Other Regulations – Regulation No. 119 (Cornering lamps)

Proposal for Supplement 5 to the 01 series of amendments to Regulation No. 119 (Cornering lamps)

Submitted by the expert from Poland*

Figure 3

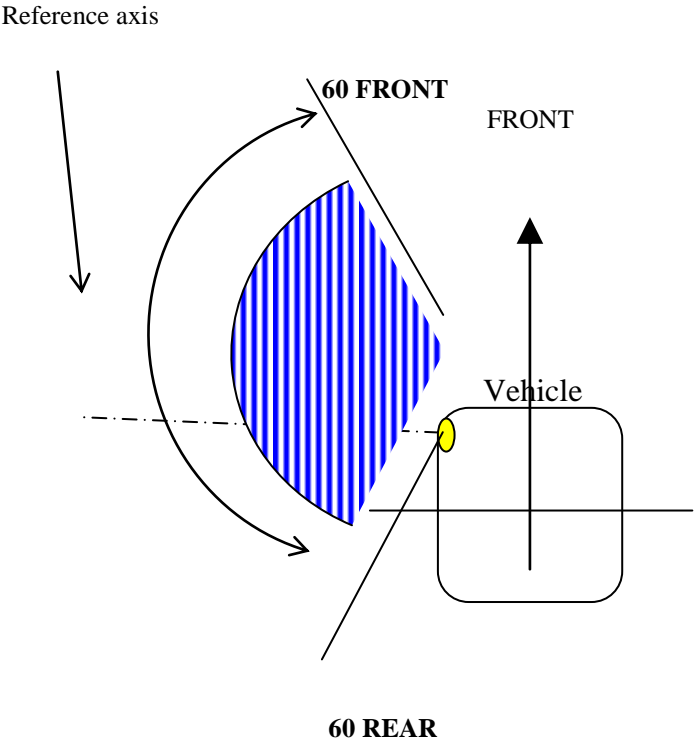
Insert new paragraph 2.2., 2.2.1. and 2.2.1.1. to read:

"2.2. Side illuminating lamp"

2.2.1.1. The directions $H = 0^\circ$ and $V = 0^\circ$ correspond to the axis of reference. On the vehicle, they are horizontal, perpendicular to the median longitudinal plane of the vehicle and oriented to the left side of vehicle. They pass through the centre of reference. The values shown in the table give the minimum intensities in cd for the various directions of measurement."
